PRODUCT CHANGE NOTIFICATION

CD Power Entry Module with Filter							
creation date	created by	release date	released by	notification no.	revision	page		
2015-01-14	hollenpe	2015-06-08	hollenpe	26910		1 of 2

KD Power Entry Module							
creation date	created by	release date	released by	notification no.	revision	page		
2015-01-14	hollenpe	2015-06-08	hollenpe	26918	_	1 of 2

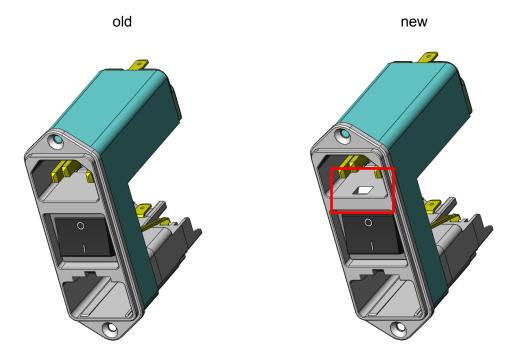
V-Lock cord retaining feature as standard.

V-Lock feature integrated as standard (not an option anymore)

Form: Yes C14 inlet with V-Lock notch as standard Fit: No There are no dimensional changes

Function: Yes V-Lock feature is standard (not an option anymore)

As the V-Lock is now a standard feature, the material numbers with index .21 are obsolete and will be replaced by the standard number:

CD61.1501.151.21 → CD61.1501.151 CD64.1101.151.21 → CD64.1101.151 CDC4.4101.151.21 → CDC4.4101.151 CDE4.4101.151.21 → CDE4.4101.151 CDM4.4101.151.21 → CDM4.4101.151

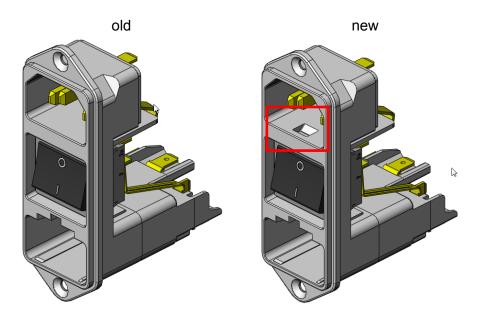
V-Lock cord retaining feature as standard.

V-Lock feature integrated as standard (not an option anymore)

Form: Yes C14 inlet with V-Lock notch as standard Fit: No There are no dimensional changes

Function: Yes V-Lock feature is standard (not an option anymore)

As the V-Lock is now a standard feature, the material numbers with index .21 are obsolete and will be replaced by the standard number:

KD13.1101.151.21 → KD13.1101.151

KD14.1101.105.21 → KD14.1101.105

KD14.1101.151.21 → KD14.1101.151

KD14.1133.151.21 → KD14.1133.151
